ENCLAVE AT EAGLE CLIFF FINAL DRAINAGE PLAN

The Vanderburgh County Drainage Board at its regularly scheduled meeting of October 28, 2014 does hereby approve the ENCLAVE AT EAGLE CLIFF FINAL DRAINAGE PLAN (hereafter referred to as the APPROVED PLAN). The APPROVED PLAN consists of the FINAL DRAINAGE PLAN SUBMITTAL, ADDITIONAL CONDITIONS OF APPROVAL OF FINAL DRAINAGE PLAN and the ADDITIONAL STIPULATIONS OF THE FINAL DRAINAGE PLAN, the contents and/or requirements of which are summarized in detail and made part of the APPROVED PLAN.

**Re: Enclave at Eagle Cliff
Swale 200 Revisions - For Approval
Morley and Associates, Inc. Project No. 8699.4.001 A**

**Re: Enclave at Eagle Cliff
Revised Drainage Plan Review Comments Response
Morley and Associates, Inc. Project No. 8699.4.001 A**

Storage Volume of Basin #1
 under the Emergency
 Overflow elevation
 Per As-built Survey data.

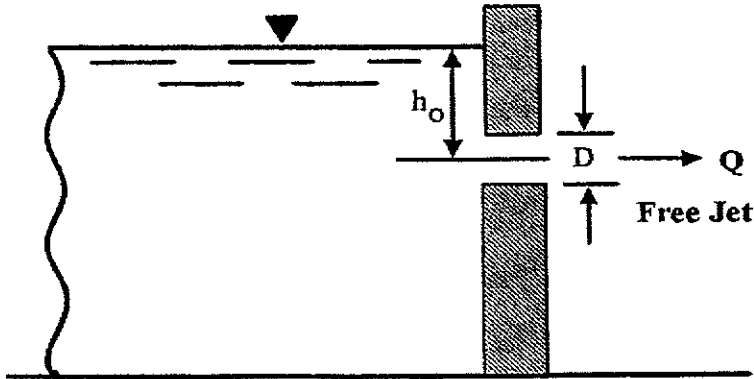
- There is no stage storage diagram for basin 1. It is unclear from the calculation page regarding basin 2 if the required storage will be met prior to the discharge through the emergency spillway. For basin 2, on the provided stage storage diagram please utilize actual elevations instead of 0,1,2, 3, 3.88 and 4. I have attached stage storage information for both basins with elevation and depth noted on each. Cannot find these.

Basin Outflow Pipe, Orifice Plate, Inlet Control

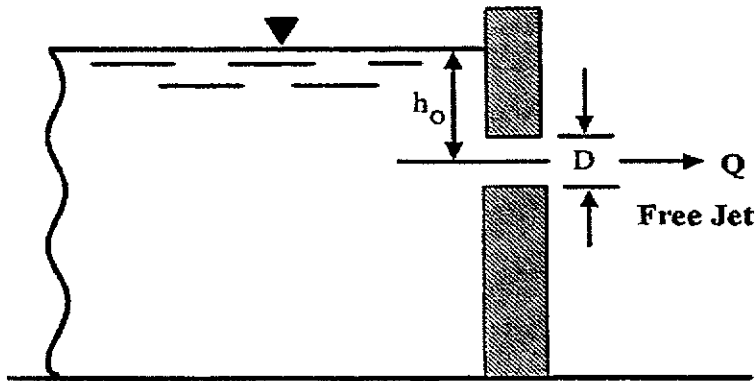
In addition to the letter I have one other question. On Basin 2, the outflow shown is the same as when previously submitted even though the outflow is now through a pipe on a much steeper slope. This does not seem possible. Can you please check this calculation/the formula being used?

Jeff,
The outflow pipe has an orifice plate on it to restrict the flow. The outflow of the orifice is based on the orifice calculation, not a pipe flow calculation, therefore the slope of the pipe does not affect the outflow volume of the orifice. Calculations for the orifice outflow volume are provided in the package I sent you in the mail last week if it wasn't included in the original submittal back in May.
